MORRISTON HOSPITAL - INFRASTRUCTURE WORKS

9A: TECHNICAL COMPLIANCE MEETINGS

Morrison Environmental Modernisation Ph 2 – Technical Compliance Group Meeting No. 07			
Date:	8 th September 2021	Time:	14:00
		Location:	Teams
Attendees:	Mark Gapper (MG)	Head of Engineering and Project Director	SBUHB
	Craig Davies (CD)	Capital Planning Project Manager	SBUHB
	Des Keighan (DK)	Asst. Director of Estates	SBUHB
	Liza Powell (LP)	Estates	SBUHB
	Phill Holmes (PH)	Estates	SBUHB
	Scott Matthews (SM)	Associate Project Manager	Mace
	Ashley Hollington (AH)	Project Manager	Mace
	Stephen Winterbourn (SW)	SCP Project Lead	Kier
	Matthew Williams (MW)	Design Manager	Kier
	Adam Rowbotham (AR)	SCP M&E Manager	Kier
	Mark Williams (MW)	Architect (Via SCP)	IBI
	Stephen Rowlands (SR)	M&E Consultant (Via SCP)	Aecom
	Jacob Loh (JL)	M&E Consultant (Via SCP)	Aecom
	Pete Thomas (PT)	M&E Consultant (Via SCP)	Aecom
	Iwan Watkins (IW)	M&E Consultant (Via SCP)	Aecom
	Adam Miezajewski (AM)	M&E Consultant (via SCP)	Aecom

John Fereedan (JF)	Structural Consultant (via SCP)	RVW
	Stephen Rees (SR)	Electrical Engineer	NWSSP-SES
	Anthony Goddard (AG)	Electrical Engineer	NWSSP-SES
	Anthony Pitcher (AP)	Fire Engineer	NWSSP-SE

Sub 6 Mark Ups

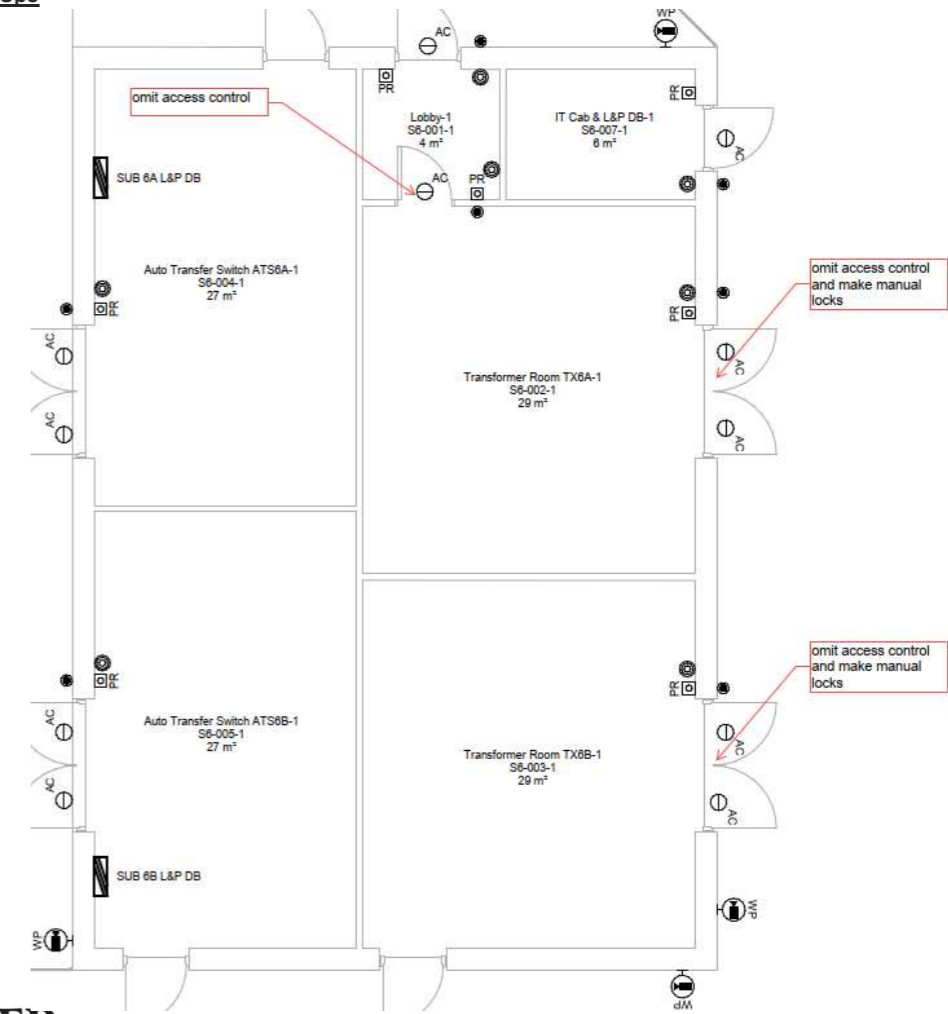
5	Boundary Treatments – Fencing, access into Sub 6 from MGW Road?	Boundary treatment around the road works to be reviewed at a latter date. To be confirmed by SBUHB.
6	Building protection – EVC's to Sub 6, bollards to service yard to protect gantry crossings.	<p>Bollard protection to gantry crossing within service yard.</p> <p>Current laundry access into dirty laundry room – external doors. Review current access and potential location of bollards.</p>

LV Switchroom Mark Ups

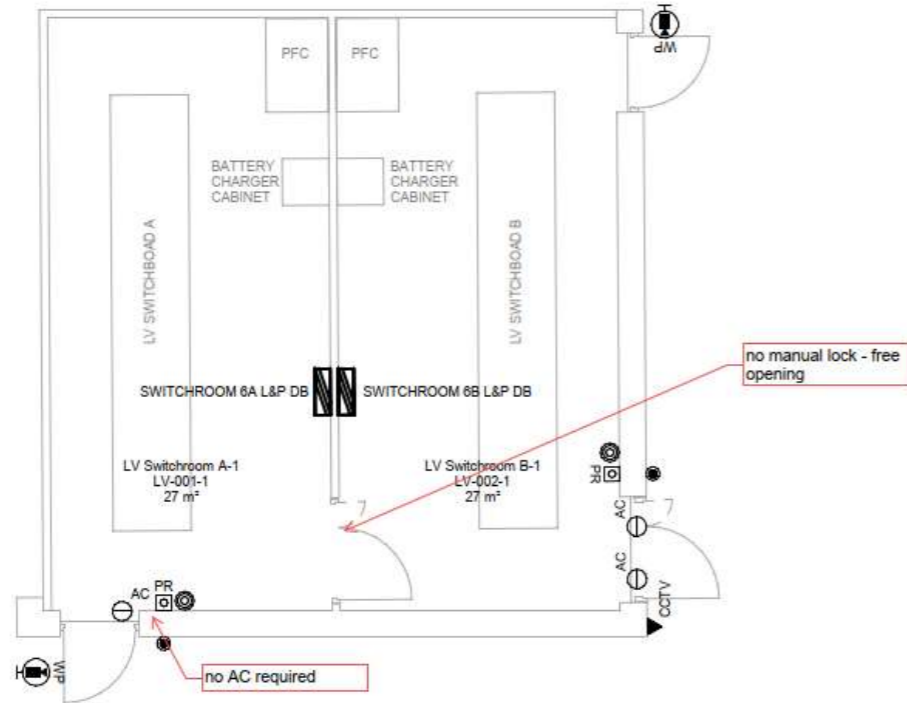
| 8 | AoB | <ol style="list-style-type: none"> 1. AP noted the door swings to LV switchroom need to be reviewed/handed. Action: To be coordinated through Stage 4. 2. Ceiling void detection – MW stated this is currently not within this proposed scheme but highlighted that from the HSDU survey the ceiling void varies dramatically in size due to the layout of plantrooms and roofs above. AP confirmed that it would be beneficial to include this as part of the scheme proposals to review exiting strategy and possibility to risk assess out the need for void detection. Kier are to progress with the baseline design (without void detection works) unless instructed otherwise. Action: SBUHB/Mace to instruct on determination? 3. Fire Stopping – MW flagged issues with existing fire stopping through HSDU. Currently not within the scope/brief of Kiers works. Action: SBUHB/Mace to instruct on determination (same time as above)? 4. MW presented HDSU fire wall findings following survey. 30min hazard rooms need to be tweaked and reissued but conclusion was that all fire walls were as noted on SWSSP original mark up which formed the basis of the Stage 3 ventilation design. Action: MW to amend fire wall DWG and reissue to all. 5. Note: No existing fire escape from back of outpatients – LP noted. 6. Note: MW to issue matterport and images above ceiling from HSDU visit. 7. Note: IBI/Kier to issue fire strategy drawings to be issued to all for final approval at the end of Stage 4. 8. Note: If the ceiling void detection works is implemented into scheme then Kier will need the risk assessment to be undertaken by project fire engineer (Zeta). |

Figure 4: Image displaying the fire resistance zone required for temporary haki stairwells against an existing building.

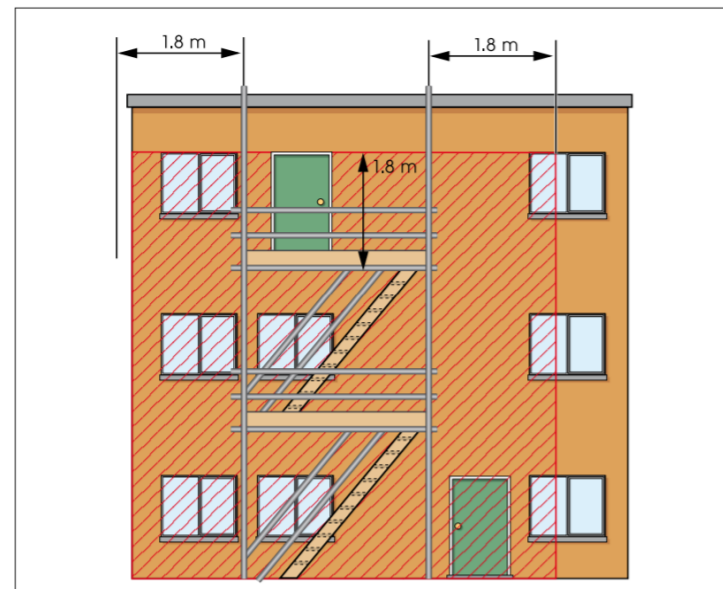
To protect the means of escape from the external scaffolding, paragraphs 206 to 207 of HSG168 should be followed. To summarise these points, ensure that either of the two following options are provided:

1. The external wall against which the stairway is erected should be imperforate and afford a nominal period of 30 minutes' fire resistance for 9m vertically below the stairway/ladder and 1.8m either side and above, as measured from the external stair/ladder treads. Or;
2. Position the haki stairwell at least 1.8m from any openings from the existing hospital building.

Figure 2: Substation

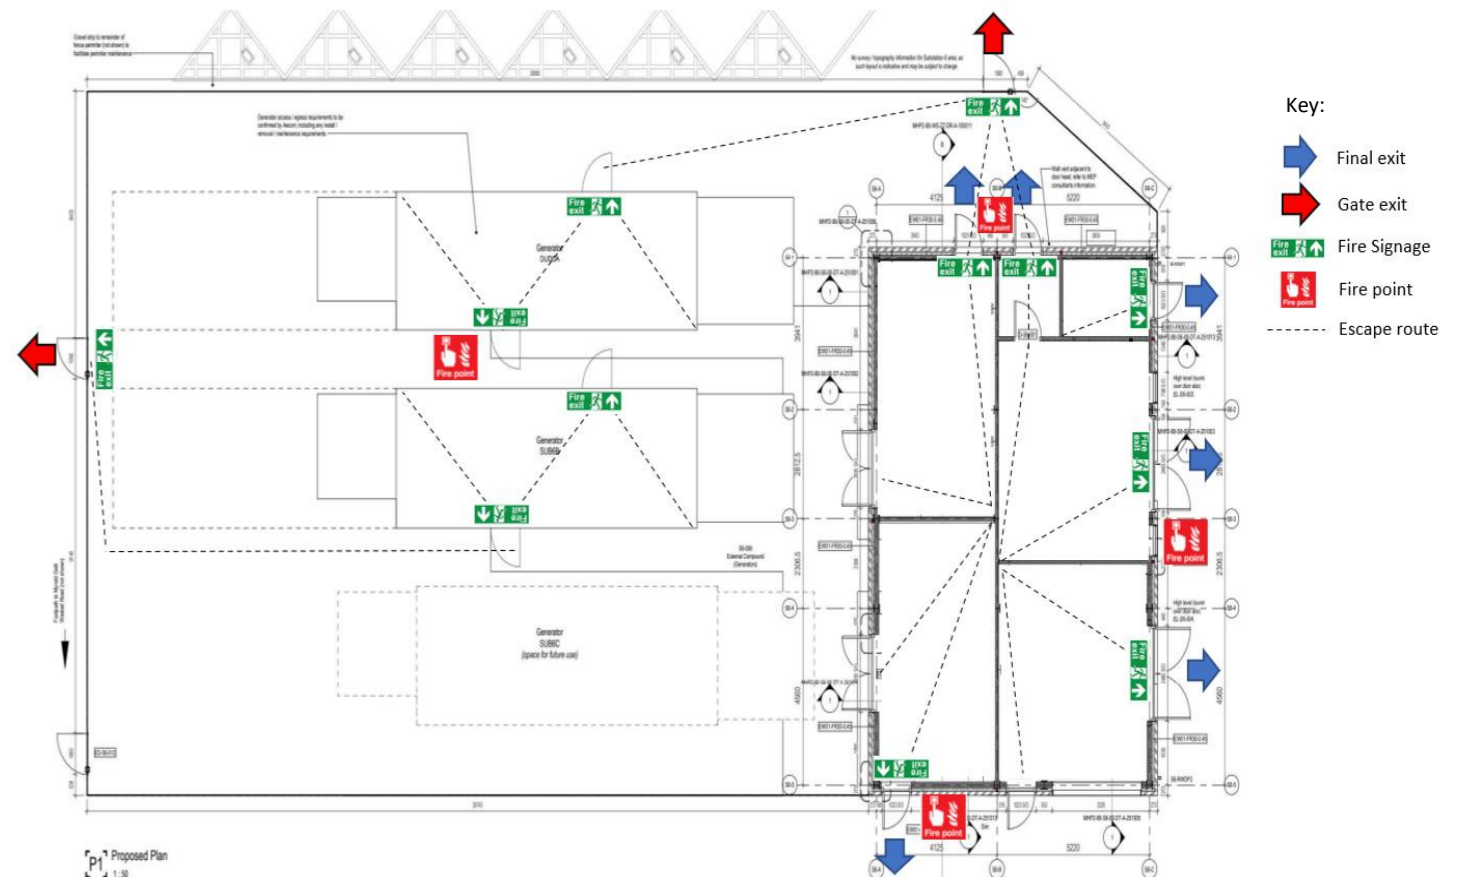
Temporary fire exit signage will need to be installed and continually reviewed throughout the project. The location of the fire exit signage is identified on the mark up floor plan as recommendations, in Appendix A.

Photo 5 – Overview of the current means of escape arrangement from plant room 4D.

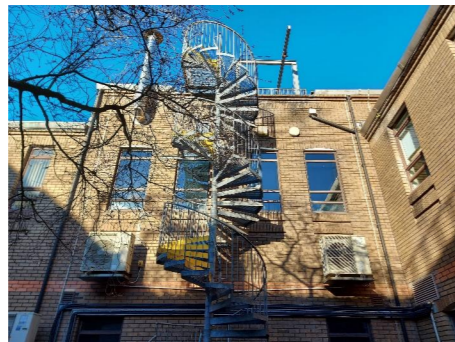
Another key factor to take into consideration is the existing means of escape arrangement from plant room 4D includes travel distances which would not be code compliant to building regulations today with particular mention of the separate compartment room within this plant room which will be occupied as part of this refurbishment project. To ensure travel distances are considered adequate, it is recommended to only occupy this compartment room whilst there are no plant and machinery blocking the escape routes within plant room 4D. This was discussed and agreed with the project manager on site.
